Access Compliance Report

(Curb Ramps)

Intersection ID: 45541	Main Street: PEACHTREE_RD	Cross Street: HARRIER_RD	Location: SW
ADA ID: 6966FB1EED5E	Ramp Type: BlendTrans2	Initial Pass/Fail: Pass	Overall Compliance: No
Severity Score: 0.25			
Codes/Mitigation Info/Possible Solution		Field Measurements/Component Compliance

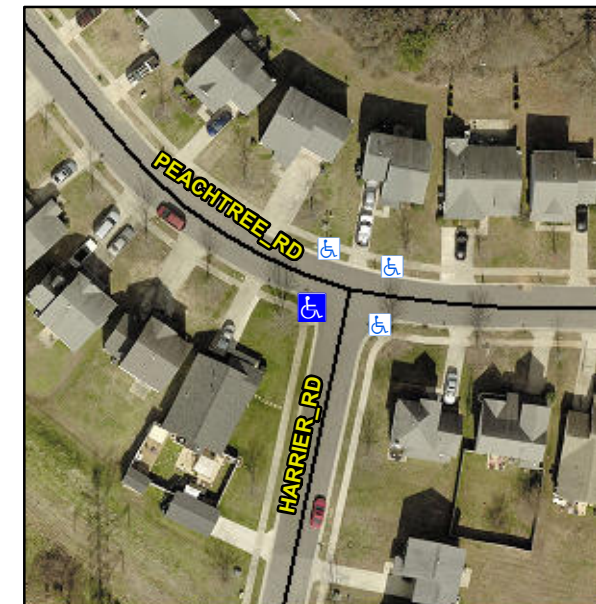
Not Found, R304.5.3, R305.2

Compliance	Description	Data	Compliance	Description	Data
N/A	Ramp Length (in)	96.5	Yes	BlendTrans Slope (%)	4.0
Yes	Ramp Width (in)	48.0	No	BlendTrans XSlope (%)	3.2
N/A	Flare Type LT	Sloped	N/A	Flare Type RT	Sloped
N/A	Flare Slope LT (%)	N/A	N/A	Flare Slope RT (%)	N/A
N/A	Flare Traversable LT?	No	N/A	Flare Traversable RT?	No
N/A	Landing Length (in)	N/A	Yes	DWS Provided?	Yes
N/A	Landing Width (in)	N/A	Yes	DWS Contrast?	Yes
N/A	Landing Slope (%)	N/A	Yes	DWS Length (in)	25.0
N/A	Landing X Slope (%)	N/A	Yes	DWS Full Width?	Yes
N/A	Landing Curb? (Y/N)	No	No	DWS Offset (in)	4.5
N/A	Shared Landing?	No			
Yes	Gutter Ponding?	No	Yes	Gutter Slope (%)	3.9
Yes	Gutter Lip Ht (in)	0.0	No	Gutter X Slope (%)	3.2
N/A	Painted X Walk1?	No	N/A	Painted X Walk2?	No
	X Walk 1 Direction	To E		X Walk 2 Direction	To N
	X Walk 1 Width (in)	N/A		X Walk 2 Width (in)	N/A
	X Walk 1 Slope (%)	0.9		X Walk 2 Slope (%)	1.5
	X Walk 1 X Slope (%)	1.2		X Walk 2 X Slope (%)	2.5

N/A	Ramp inside XWalk1?	N/A	N/A	Ramp inside XWalk2?	N/A
	Road Slope (%)	1.4		Clear Space?	Yes
	Road X Slope (%)	1.9	N/A	Clear Space to XWalk (in)	N/A
Yes	Any Obstructions?	No	Yes	Storm Grate/Utility Hazard?	No
	Obstruction Type			Storm Grate/Utility Type	
		N/A			N/A
			Yes	Surface Condition? (G/P)	Good
			No	Curb Slope (%)	15.2

Remove & Replace Curb Ramp With Two New Directional Ramps or Equivalent. Remove & Replace Gutter.
